TECHNICAL BULLETIN

ALLISON 250-C30 ENGINE INSTALLATION SURGE FIX MODIFICATION

369F/FF Helicopters serial number 0001-0133, 0600-0602, 0700-0702.

Some 369F/FF helicopters have experienced engine compressor surges. Complying with this Bulletin will reduce possibility of continued engine surges. Helicopter serial number 0134 thru 0599 have the intent of this Bulletin completed before delivery.

Figure 1. Structural Modifications

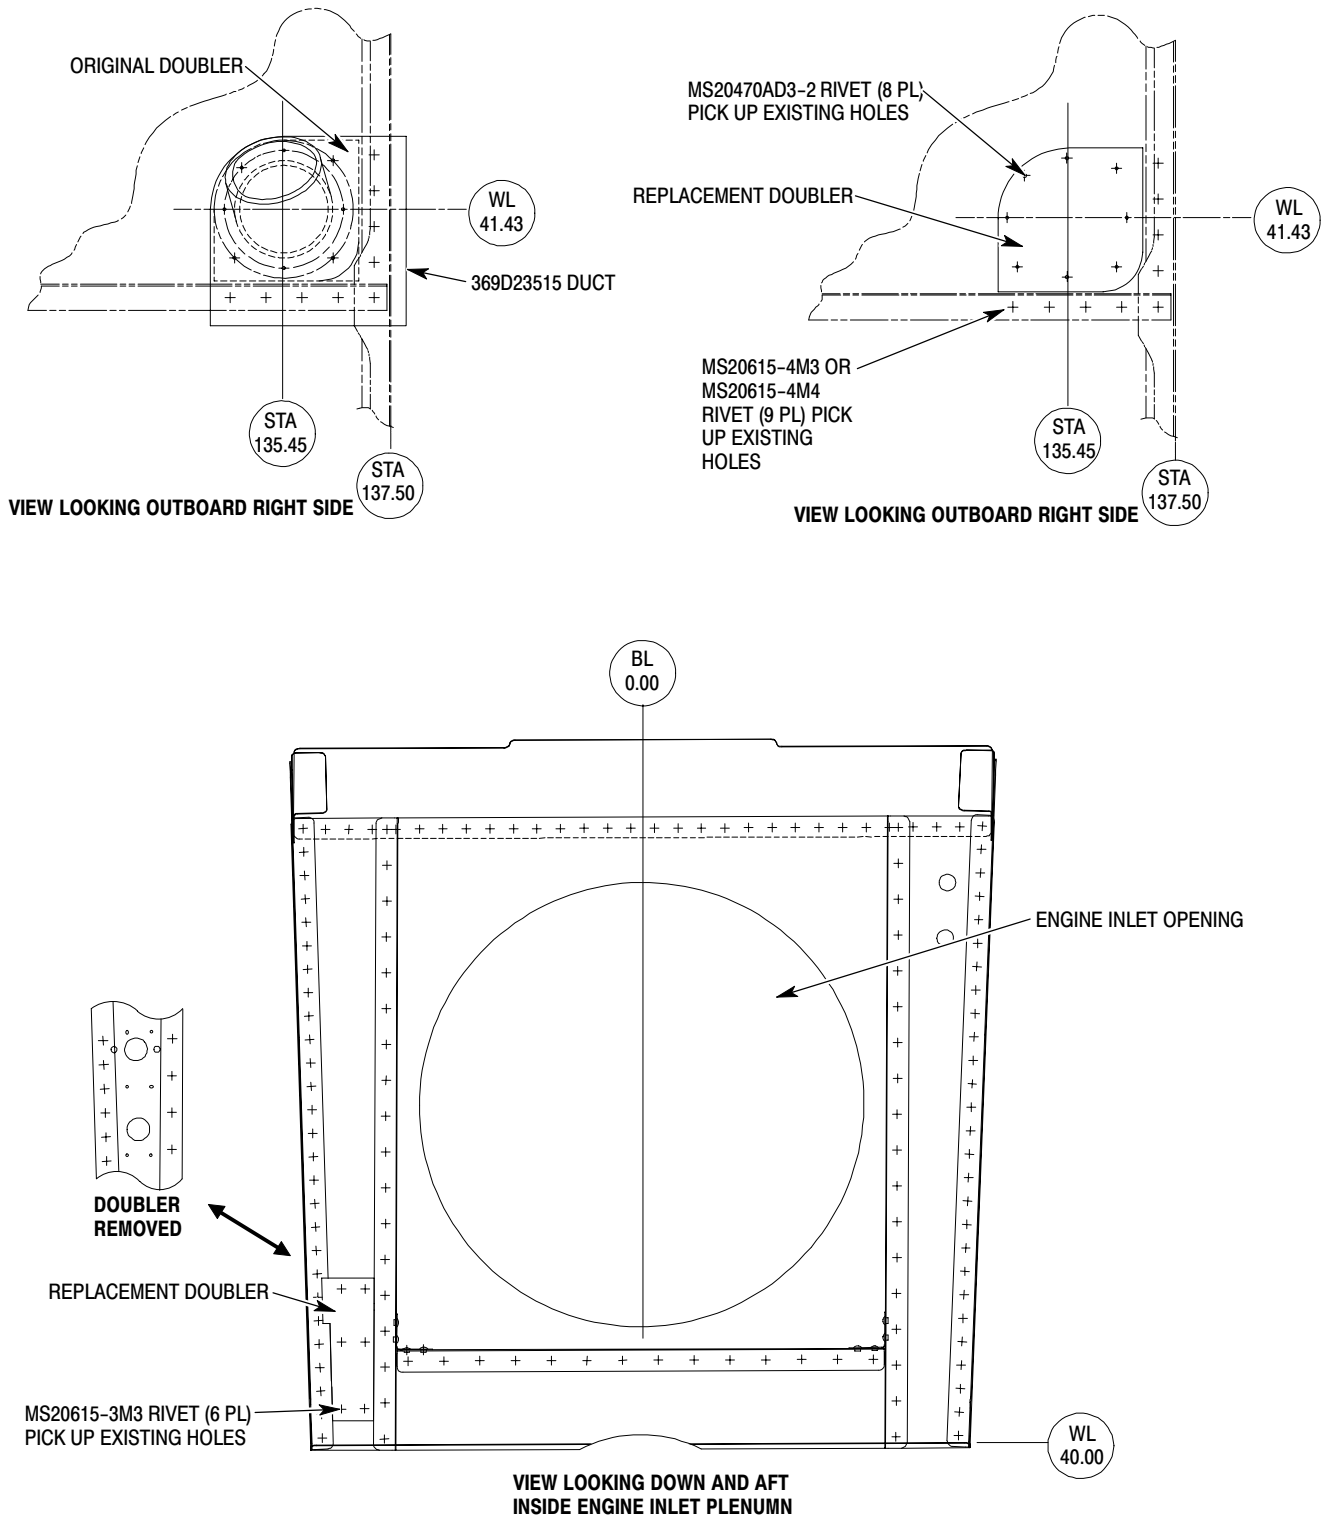
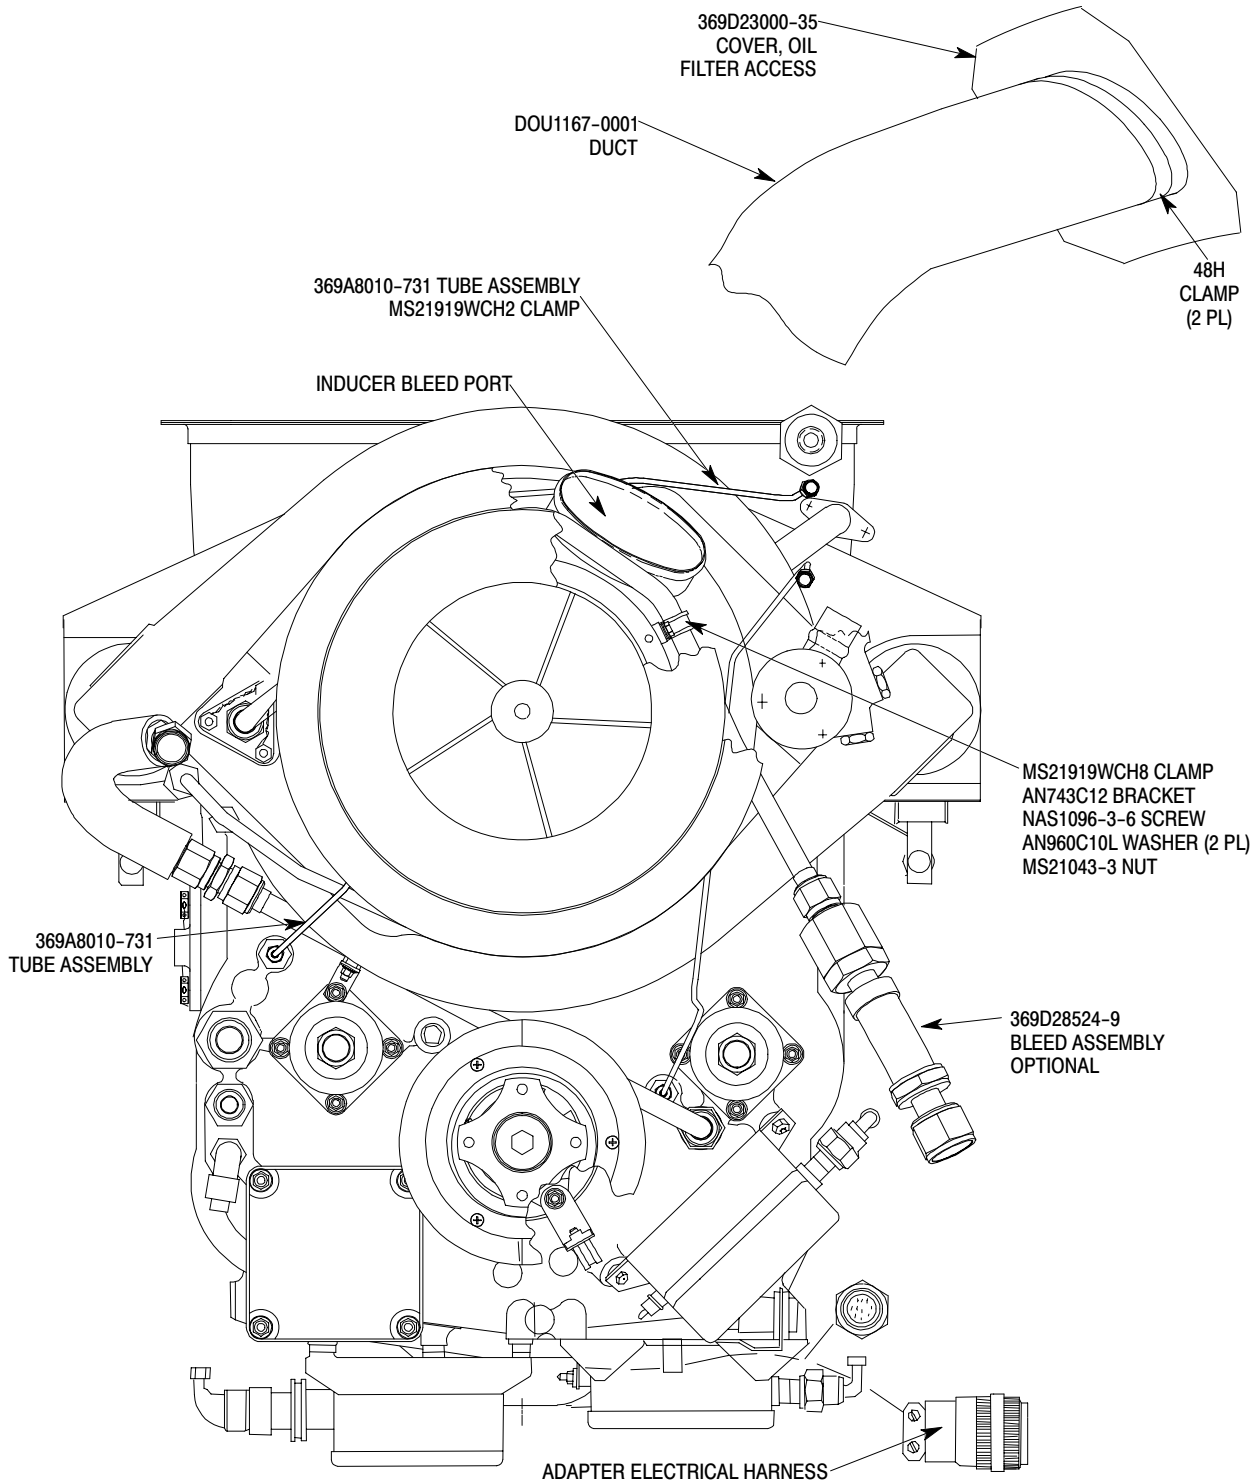
- (1). Remove engine (Ref. CSP-HMI-2).
- (2). Remove T1 temperature sensor from bottom of engine inlet plenum (Ref. CSP-HMI-2).

NOTE: There are two acceptable methods to cover the hole in the plenum wall. The existing doubler with holes may be removed, and a new doubler without holes installed. An alternate is to leave the existing doubler in place and install a plug button in the hole.

- (3). Doubler replacement method:
 - (a). Remove existing T1 doubler from plenum wall.
 - 1). Remove six (6) MS20615-3M rivets with a number forty (40) drill bit.

- 2). Remove doubler and discard.
 - (b). Remove all sealant residue and clean area.
 - (c). Install replacement T1 doubler 369DSK400-163.
 - 1). Align replacement doubler over holes in plenum wall and pick up existing rivet holes.

- 2). Drill rivet holes with a number forty (40) drill bit and deburr.
 - 3). Install replacement doubler with MS20615-3M3 rivets. Install rivets wet with MIL-P-23377, T1, C3 primer.

- 4). Seal all open gaps and crevices with Silastic RTV 732.
- (4). Alternate plug button installation method:
 - (a). Remove all residue and clean area.

- (b). Install HS4248C40 plug button:
 - 1). Install plug button with head on plenum (forward) side of plenum wall.
 - 2). Bend all tabs outboard, flush with plenum wall.

- 3). Wipe with isopropyl alcohol or equivalent and air dry fifteen minutes
 - 4). Seal plug button with a 0.125 in (3.1 mm) bead of Pro Seal 700.
 - 5). Cure seal in accordance with manufacturer's instructions.

- (5). Touch up white paint (Ref. CSP-HMI-2).
- (6). Remove 369D23515 duct.
 - (a). Remove eight (8) MS20470AD3 with a number forty (40) drill bit.
 - (b). Remove nine (9) MS20615-4M rivets with a number thirty (30) drill bit.

- (c). Remove duct and discard.
 - (d). Fill nine (9) unused holes with MS20615-4M3 or MS20615-4M4 rivets. Install rivets wet with MIL-P-23377, T1, C3 primer.

- (e). Align replacement 369DSK400-165 doubler with over holes in aircraft skin and pick up existing rivet holes.
 - (f). Drill rivet holes with number forty (40) drill bit and deburr.

- (g). Install replacement doubler with MS20470AD3-2 rivets. Install rivets wet with primer MIL-P-23377, T1, C3 primer.
 - (h). Seal all open gaps and crevices with Silastic RTV 732.

- (1). Build up engine in accordance with CSP-HMI-2, with the following exceptions.
 - (a). If installing 369D28524-9 improved bleed assembly, install.
 - 1). Install MS21919WCH8 clamp, AN743C12 bracket, NAS1096-3-6 screw, AN960C10L washers, and MS21043-3 nut.
 - 2). Install 369A8010-731 tube assembly and MS21919WCH2 clamp. Attach clamp at existing clamp point with existing hardware.

Figure 3. Electrical Modification -513 Aircraft S/N 001 Thru 075

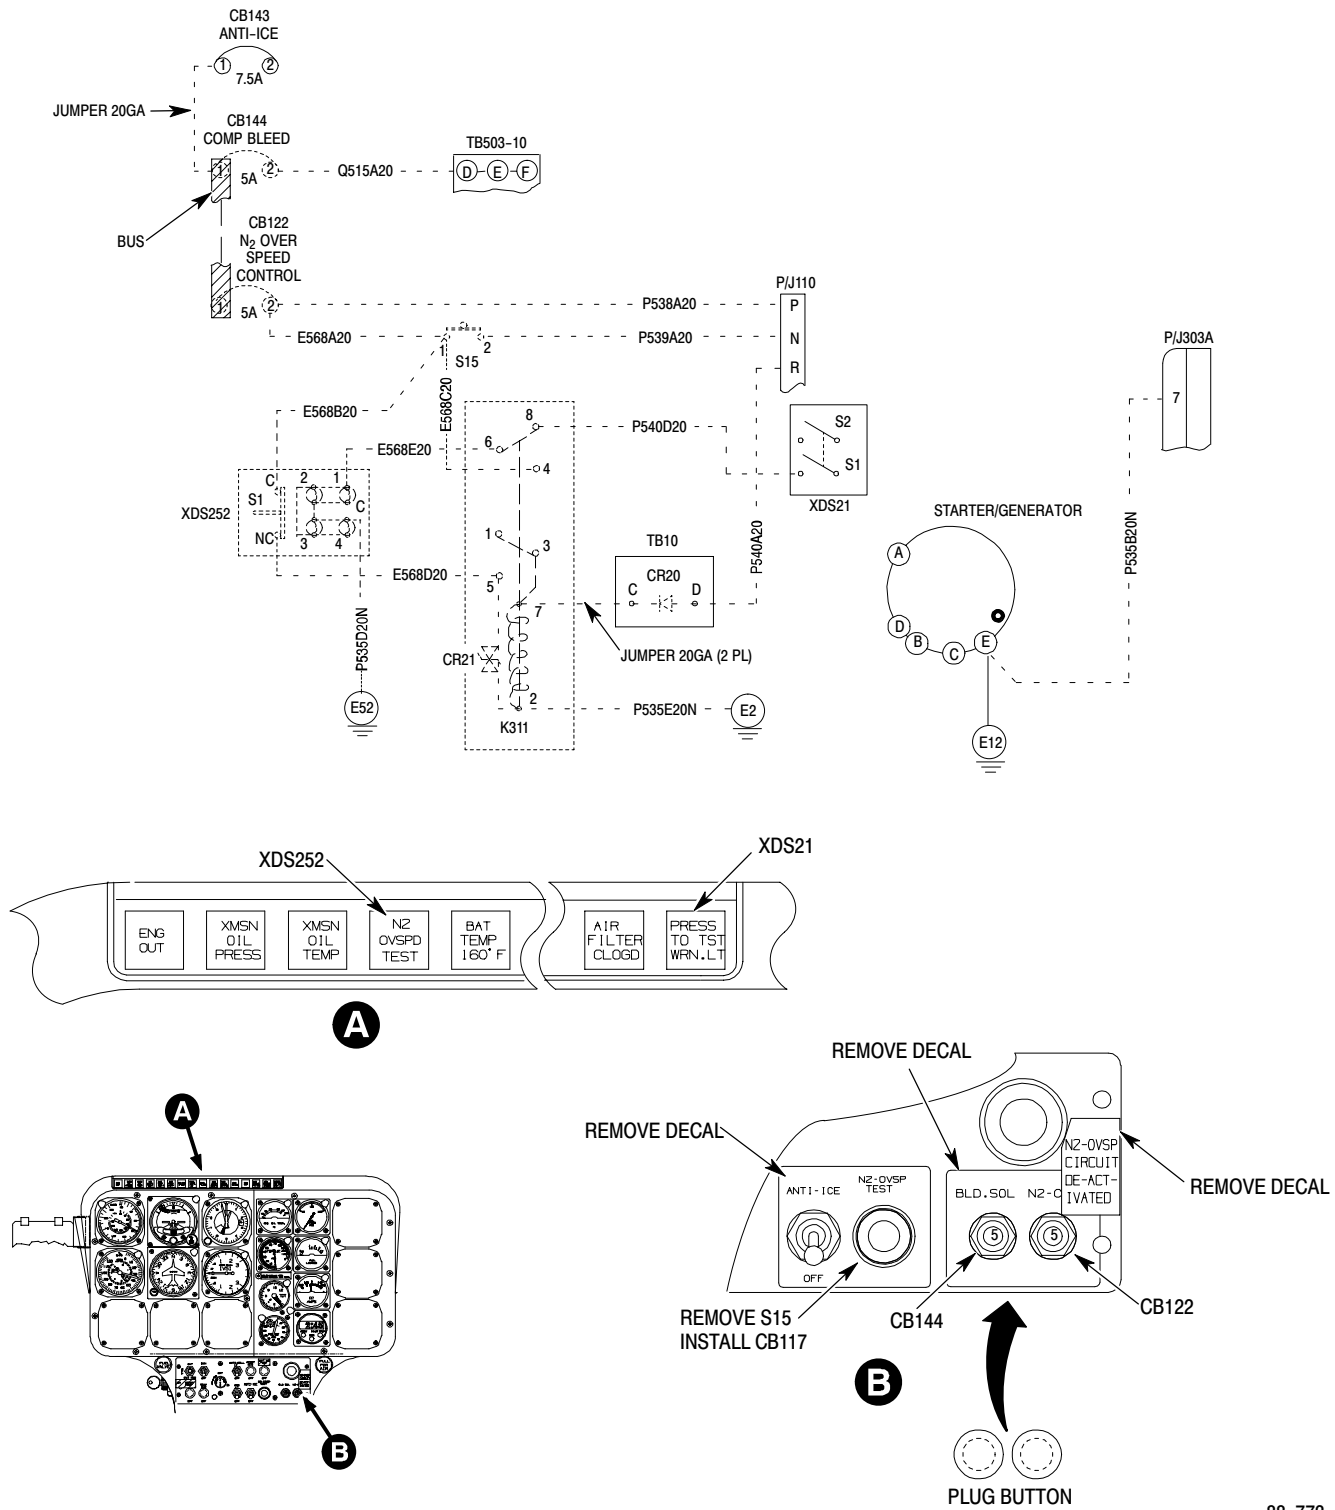
- (1). Remove 20GA jumper from CB143-1 and CB144-1 and discard.
- (2). Remove wire number Q515A20 from CB144-2 and cap and stow.
- (3). Remove wire number P538A20 from CB122-2 and cap and stow.

- (4). Remove wire number E568A20 from CB122-2 and S15-1 and discard.
- (5). Remove wire number E568B20 from S15-1 and XDS252-C and cap and stow.
- (6). Remove wire number E568C20 from S15-1 and K311-4 and cap and stow.

- (7). Remove wire number P539A20 from S15-2 and cap and stow.
- (8). Remove CB144 (Compressor Bleed) and CB122 (N₂ Overspeed) and discard.
- (9). Remove S15 (N₂ Overspeed Test) and discard.

- (10). Remove M50465 (N₂-OVSP CIRCUIT DE-ACTIVATED) decal from switch panel and discard.
- (11). Remove decals for CB144, CB122, and S15 from switch panel and discard.

- (12). Install plug buttons in removed circuit breaker locations and paint to match panel.
- (13). Install Utility Switch/Breaker (CB117) into hole from removal of S15.

- (14). Install 369D28560-25 (UTIL/LTR) decal above CB117.
- (15). Remove utility power wires M501A20 and P506AF16 from CB208 in circuit breaker panel and connect to CB117 in switch panel.

- (16). Remove the 369D28560-25 (UTIL/LTR) decal from circuit breaker panel above CB208 and uncover "RADALT" on panel.
- (17). Remove wire number E568E20 from XDS252-1 and K311-6 and cap and stow.

- (18). Remove wire number E568D20 from XDS252-NC and K311-5 and cap and stow.
- (19). Remove wire number P535D20N from XDS252-4 and E52 and cap and stow.

- (20). Remove XDS252 (Switch/Light N₂ Overspeed) and discard.
- (21). Fill hole from removed XDS252 with a 369D26451-7 blank.
- (22). Remove wire number P540D20 from K311-8 and XDS21 and cap and stow.

- (23). Remove wire number P535E20N from K311-2 and E2 and cap and stow.
- (24). Remove 20GA jumper from K311-7 and TB10-C and discard.
- (25). Remove K311 (Overspeed Relay) and discard.

- (26). Remove wire number P540A20 from TB10-D and cap and stow.
- (27). Remove diode from TB10-C and TB10-D and discard.

Figure 4. Electrical Modification -511 Aircraft S/N 076 Thru 133

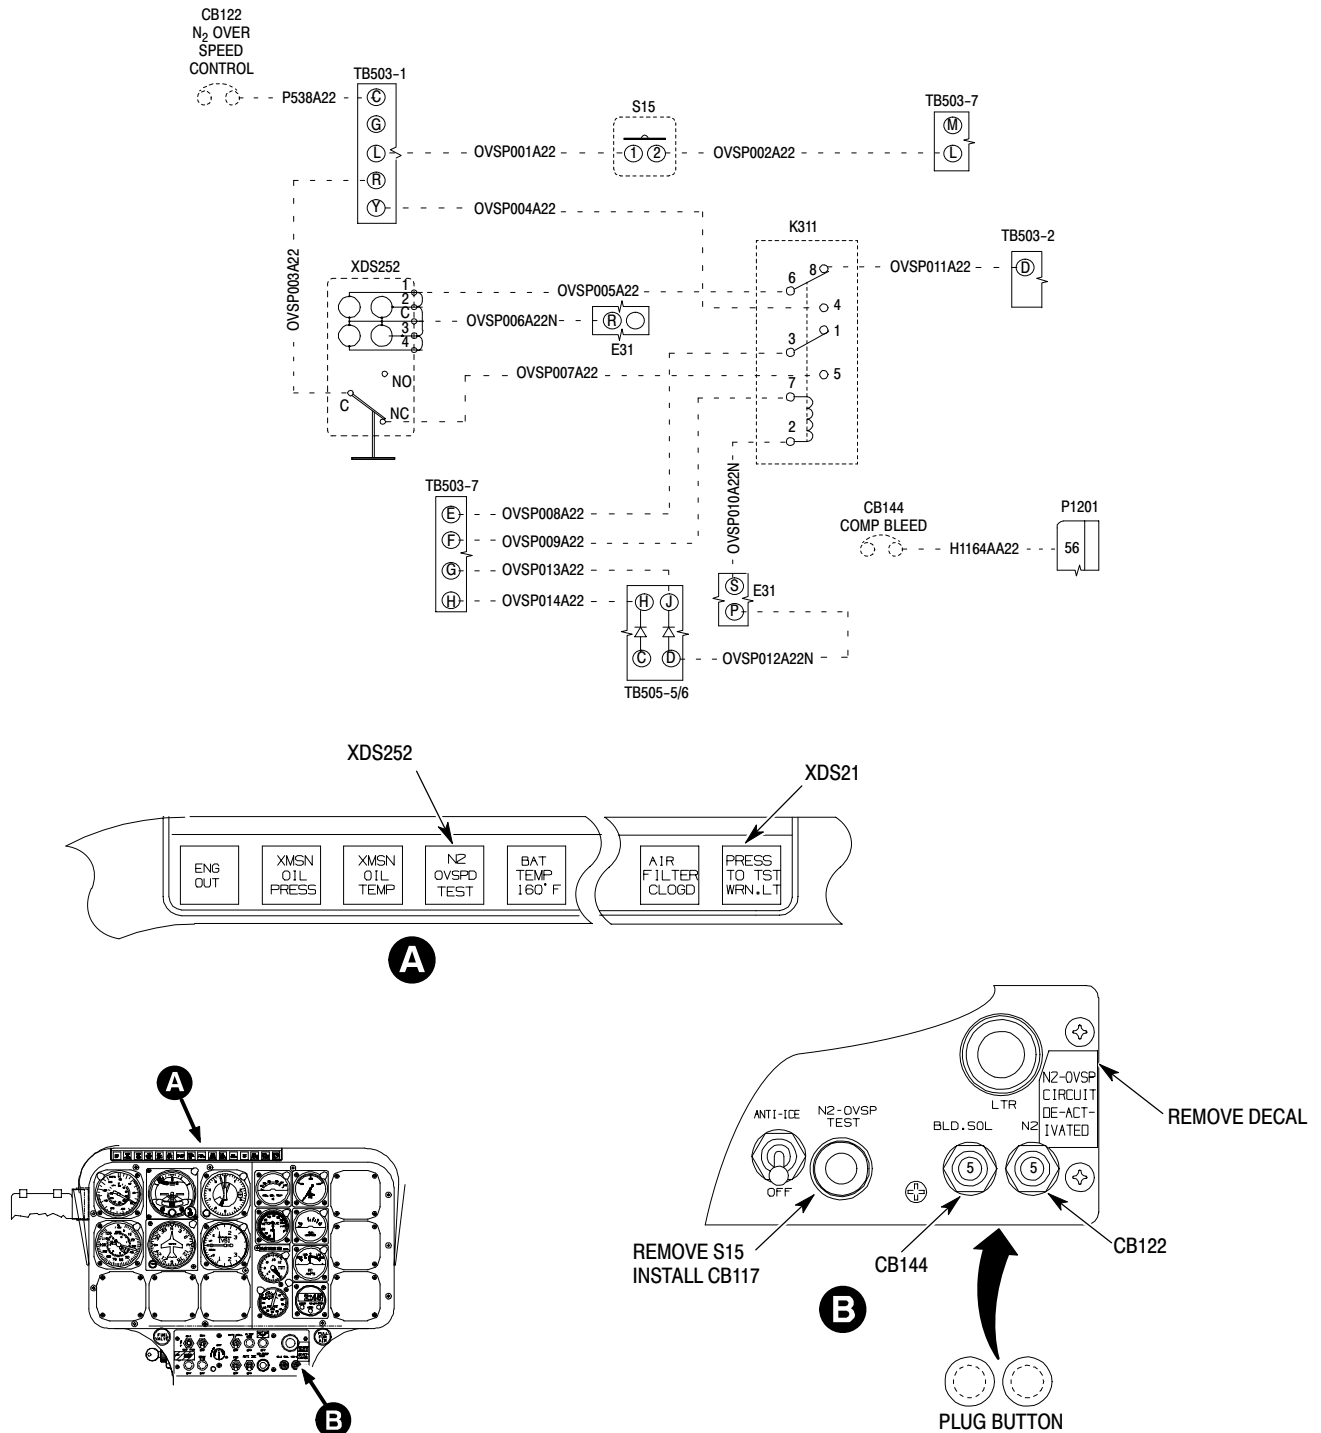
- (1). Remove wire number P538A22 from CB122 and cap and stow.
- (2). Remove wire number H1165AA22 from CB144 and cap and stow.
- (3). Remove CB144 (Compressor Bleed) and CB122 (N₂ Overspeed) and discard.

- (4). Remove wire number OVSP001A22 from S15-1 and cap and stow.
- (5). Remove wire number OVSP002A22 from S15-2 and cap and stow.
- (6). Remove S15 (N₂ Overspeed Test) and discard.

- (7). Remove M50465 (N₂-OVSP CIRCUIT DE-ACTIVATED) decal from switch panel and discard.
- (8). Cover switch and circuit breaker panel legend for CB144 and CB122 with black background decal material.

- (9). Install plug buttons in removed circuit breaker locations and paint to match panel.
- (10). Install Utility Switch/Breaker (CB117) into hole from removal of S15.

- (11). Install 369D28560-25 (UTIL/LTR) decal above CB117.
- (12). Remove utility power wires M501A20 and P506AF16 from CB208 in circuit breaker panel and connect to CB117 in switch panel.

- (13). Remove the 369D28560-25 (UTIL/LTR) decal from circuit breaker panel above CB208 and uncover "RADALT" on panel.
- (14). Remove wire number OVSP003A22 from XDS252-C (switch circuit) and cap and stow.

- (15). Remove wire number OVSP005A22 from XDS252-1 and cap and stow.
- (16). Remove wire number OVSP006A22 from XDS252-C (light circuit) and cap and stow.

- (17). Remove wire number OVSP007A22 from XDS252-NC and cap and stow.
- (18). Remove XDS252 (Switch/Light N₂ Overspeed) and discard.
- (19). Fill hole from removed XDS252 with a 369D26451-7 blank.

- (20). Remove wire number OVSP004A22 from K311-4 and cap and stow.
- (21). Remove wire number OVSP005A22 from K311-6 and cap and stow.
- (22). Remove wire number OVSP008A22 from K311-3 and cap and stow.

- (23). Remove wire number OVSP009A22 from K311-7 and cap and stow.
- (24). Remove wire number OVSP007A22 from K311-5 and cap and stow.
- (25). Remove wire number OVSP010A22N from K311-2 and cap and stow.

- (26). Remove wire number OVSP011A22 from K311-8 and cap and stow.

- (27). Remove K311 (Overspeed Relay) and discard.
- (28). Remove wire number OVSP012A22N from TB505-5/6D and cap and stow.
- (29). Remove wire number OVSP013A22 from TB505-5/6J and cap and stow.
- (30). Remove wire number OVSP014A22 from TB505-5/6H and cap and stow.

Figure 5. Field Fabrication of Doublers

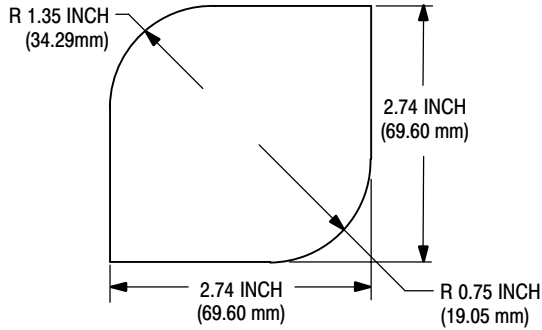
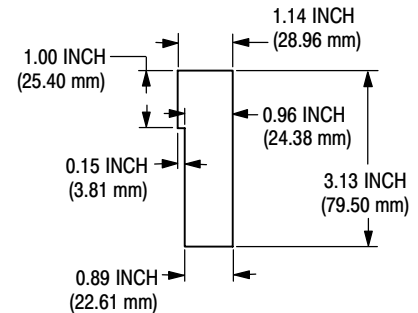
1. MAKE FROM 0.020 INCH (0.51 mm) X 3.00 INCH (76.2 mm) X 3.00 INCH (76.2 mm) 2024-T3 AL ALY SHT, 00-A-250/4.
2. CHEMICAL TREAT PER MIL-C-5541, CLASS 1A.
3. APPLY MIL-P-23377, TYPE 1, CLASS C, EPOXY PRIMER.
4. APPLY HMS15-1100, TYPE 2 EPOXY ENAMEL TO MATCH SURROUNDING AREA AFTER INSTALLATION.

1. MAKE FROM 0.020 INCH (0.51mm) X 3.00 INCH (76.2 mm) x 3.00 INCH (76.2 mm) 301 CRES SHT, COND 1/2 HARD, 00-5-799.
2. PASSAVITAION TREATMENT PER QQ-P-35.
3. APPLY MIL-P-23377, TYPE 1, EPOXY PRIMER.
4. APPLY HMS15-1100, TYPE 2 EPOXY ENAMEL TO MATCH SURROUNDING AREA AFTER INSTALLATION.
